Draft Decision on the Western Power Networks Business Unit Proposed Access Arrangement for the South West Interconnected Network

Submitted by Western Power Corporation

21 March 2006

Economic Regulation Authority

Figure 1 Peak demand (MW)⁷⁹

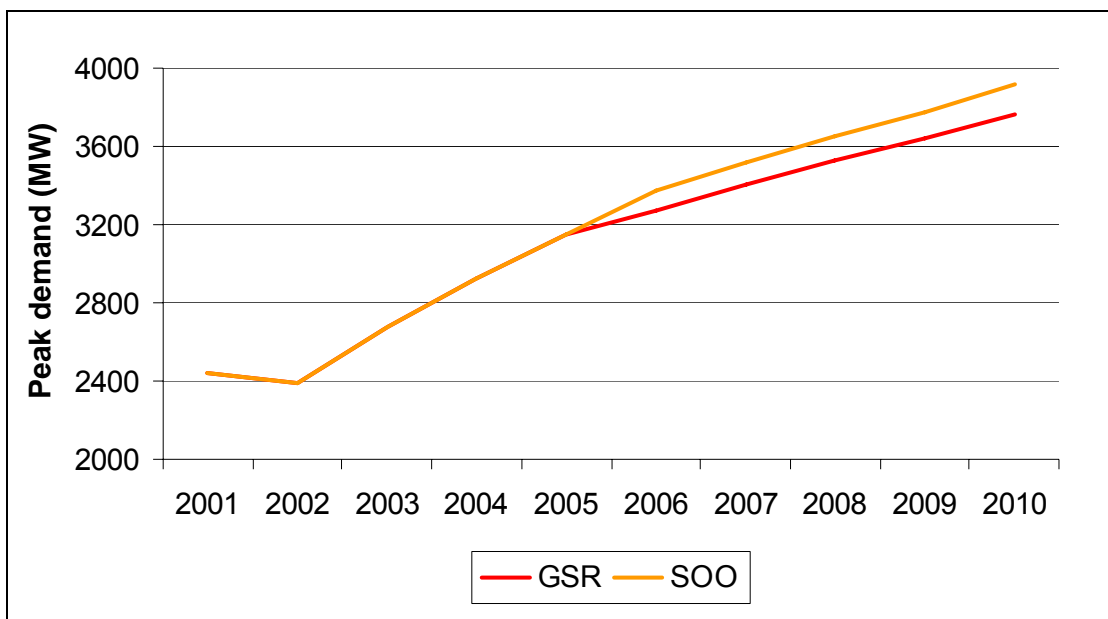
Figure 1 compares the forecast peak demand in the 2004 GSR with that in the 2005 SOO and it can be seen that the SOO forecast is some 120 MW higher than that in the GSR. This difference is believed to be due to increases in air-conditioning purchases and usage. There was very hot weather in 2002/03 and this most likely prompted extra purchases which would have contributed to above forecast demand in 2003/04 and 2004/05.⁷⁸

Western Power to revise its maximum demand forecasts.

Figure 2 Adjusted IMO Energy Forecast (GWh)

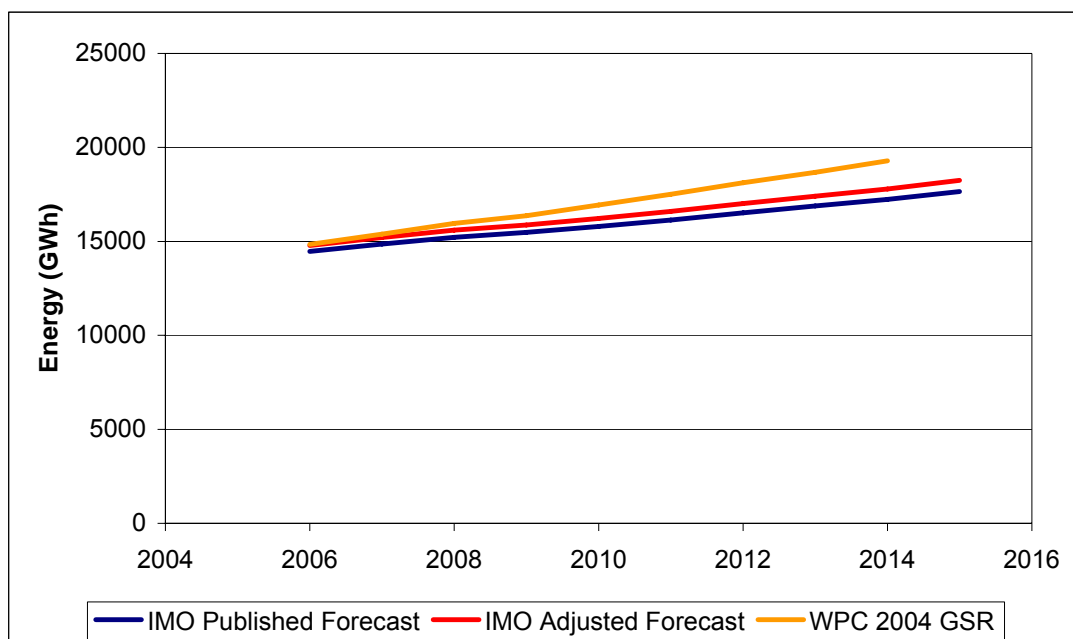
194. The comparison between the energy forecasts contained within the 2004 GSR and the 2005 SOO (as published and as adjusted) is shown in Figure 2.

195. The IMO noted that the 2005 SOO forecast shows a lower growth rate than was forecast in the 2004 GSR. In its report to the IMO, NIEIR commented that the energy forecasts had been revised downwards quite significantly. One of the factors driving this was a reassessment of the historical energy growth using an alternative weather normalisation process. NIEIR had found that the weather normalised growth in energy in previous forecasts was too high based on recent experience.

Western Power to revise its forecast transmission energy, having regard to the Independent Market Operator's submission "sent out energy forecasts" for the period 2006/07 to 2008/09 at the expected growth rates in accordance with Table 6 above.

Figure 9.1: Opex per Unit of Network Investment (%)

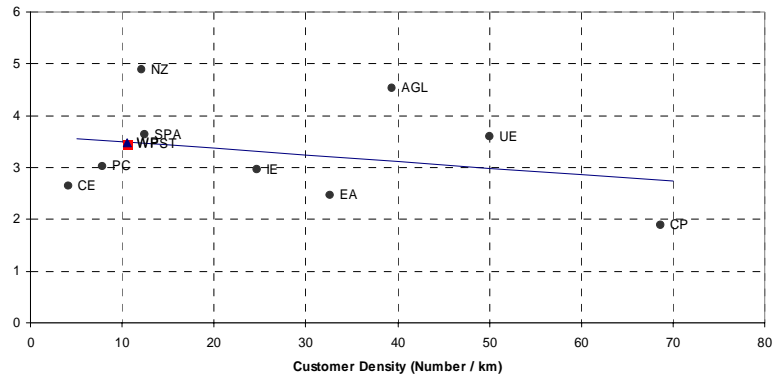
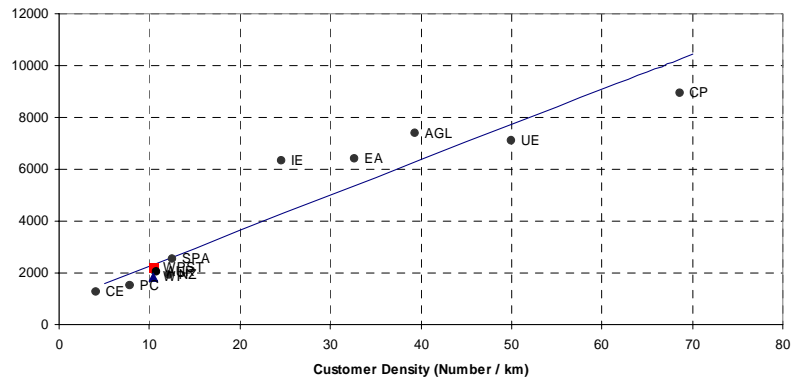
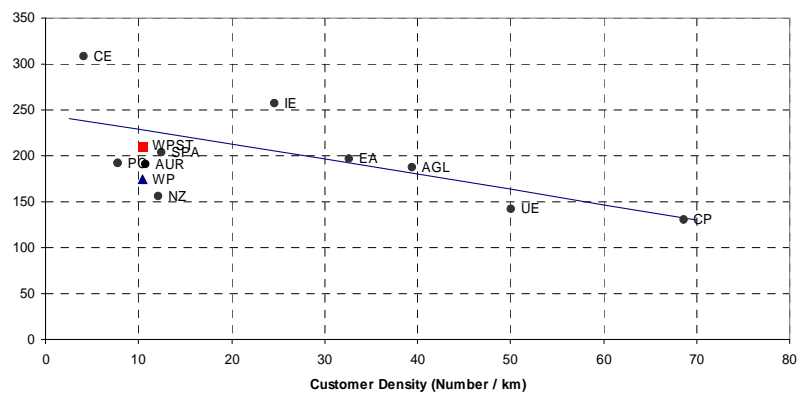
Figure 9.1 shows that Western Power's opex is at the high end of the range but has costs per unit of network investment on the best-fit line. Likewise in the case of figure 9.2, cost per km. In figure 9.3, cost per customer, Western Power's expenditure is below the best-fit line. Western Power's position excluding sub-transmission (the WP points in the figures) differs slightly in most cases.

9.3 Trade-Off between Reliability and Opex

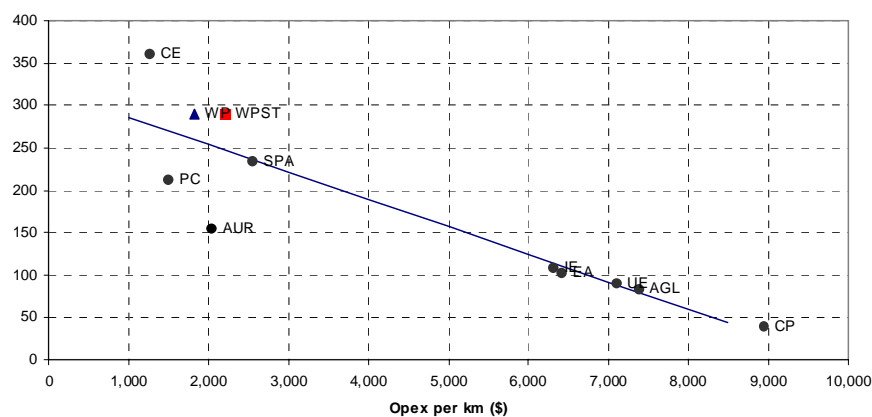
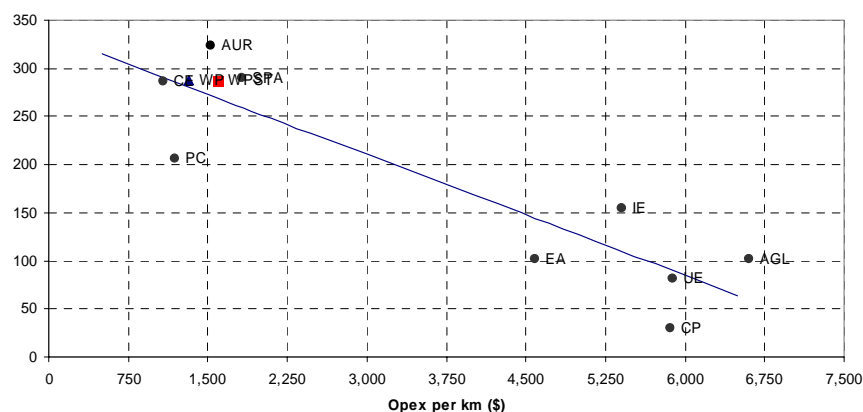
The following supplementary figures examine the trade-off between reliability, measured by SAIDI, and opex, measured per km of line length, for the businesses.⁸² The best-performing businesses achieve better-than-average reliability with lower-than-average cost.

The first figure shows that Western Power is amongst the worst-performing in terms of reliability but amongst the lowest in terms of cost.
